Date: June 3, 2024

Subject: Response to April 17, 2024 Comments - Response to *Interim Long Term Monitoring Plan for Groundwater and Surface Water, Tyco FTC PFAS, 2700 Industrial Parkway South, Marinette, WI, BRRTS #02-38-580694*

WDNR Comments and Tyco Responses

FIGURE
5

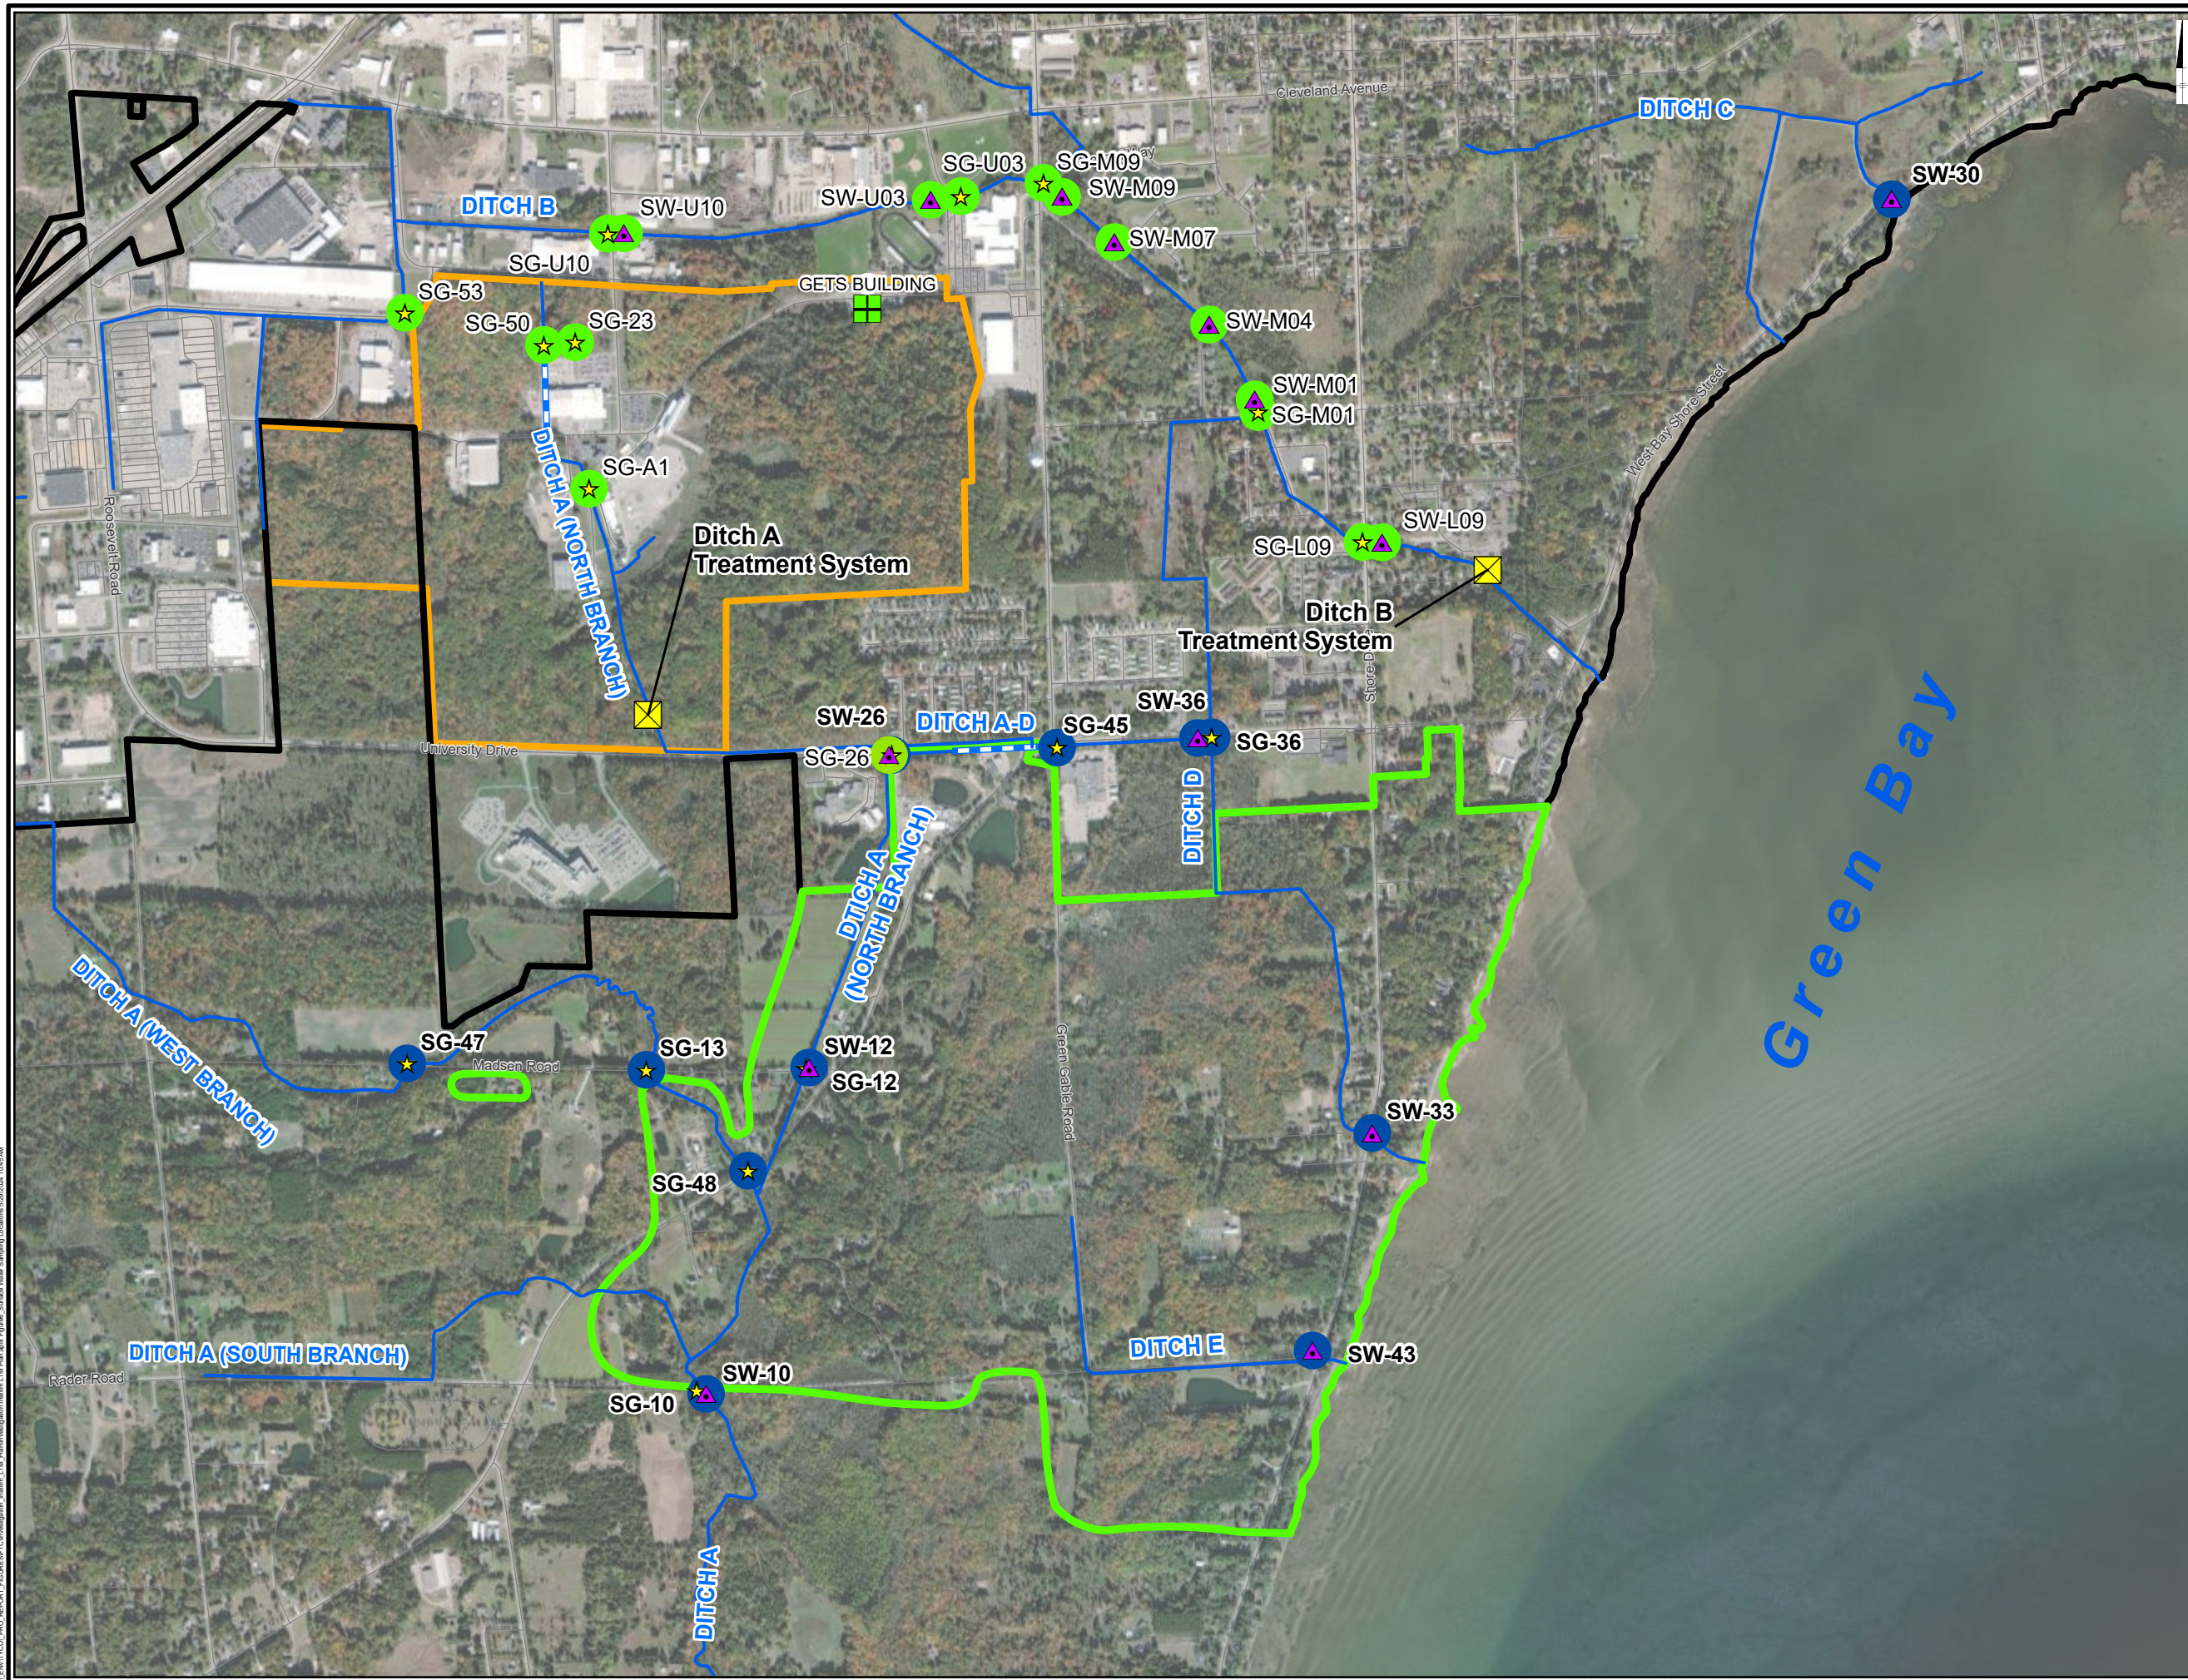
Recommendation #3 (Monitoring Well Subtractions): *If JCI/Tyco would like to off-set some of the additions recommended above, the DNR has identified three monitoring wells currently included in the Interim Monitoring Plan where PFAS sampling is not necessarily needed (see **Attachment A Table**). These wells could be subtracted from the monitoring program at this time. The DNR also understands that JCI/Tyco may propose subtracting or reducing the sampling frequency at the other monitoring wells during the 5-year monitoring period based on its evaluation of the PFAS sampling results.*

The DNR recommended removing three monitoring wells (PZ-35-48, TW-04, and TW-01) from the Interim LTM Plan. Tyco agrees with removing PZ-35-48 and TW-01 from the Interim LTM Plan. TW-04 will be retained at this time. If it is determined that location “K” should be monitored instead of TW-04, this adjustment will be made to the sampling plan.

Tables 1 and 2 and Figures 2 and 5 of the Interim LTM Plan (enclosed) have been revised to reflect these changes.
